#66-F-231C
W.P. #108-66
HWY #23
MAITLAND
RIVER
(BOYLE DRAIN)

DEPARTMENT OF HIGHWAYS ONTARIO BRIDGE DIVISION			
MAITLAND RIVER BRIDGE			
8.7 MILES SOUTH OF SOUTH JCT. HWY. #86			
KING'S HIGHWAY No. 23		DIST. No. 3	
CO.		CON. 13	
TWP. OF ELMA		LOT 15 & 16	
PRELIMINARY			
APPROVED		SITE No. 25-72 W.P. No. 108-66	
DESIGN	J. L.	CHECK	
DRAWING	B. S. A.	CHECK	
DATE	OCT/66	LOADING	H520-46
CONTRACT No.		DRAWING No. D-6062-P

SOILS INVESTIGATION REPORT
PROPOSED BRIDGE-HIGHWAY 23 & BOYLE DRAIN

W.F. 108-66, Bridge Site 25-72
Maitland River (Boyle Drain) Bridge
8.7 Miles South of South Jct. Hwy. #86
Highway #23
District #3, Stratford

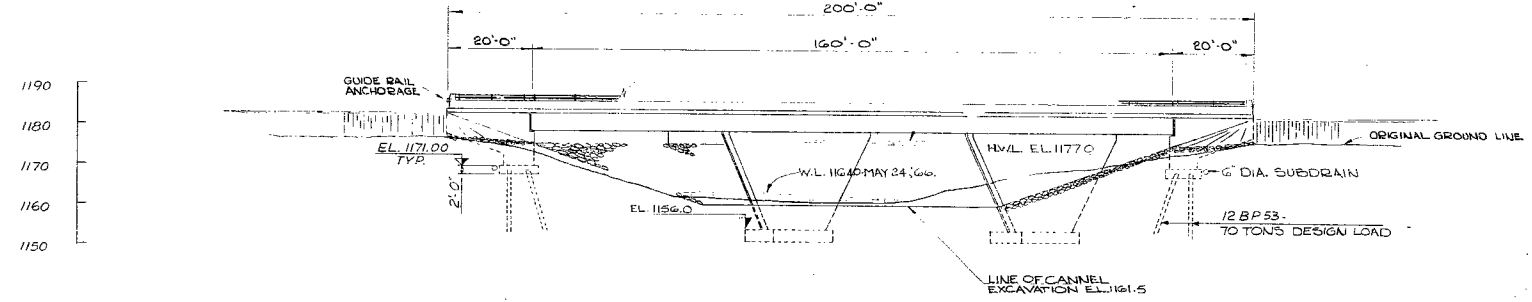
We have reviewed preliminary Plan D-6062-P for the above-noted structure.

The Designer appears to have complied with the recommendations contained in the Foundation Report: Using spread footings with a safe design load of 2.0 T.S.F. for the proposed piers.

We note that the abutments will be supported on 12 BP 53 piles with a design load of 70 tons per pile.

It is believed that this design load could be achieved between El. 1130 and El. 1140.

We have no further comment on this subject.
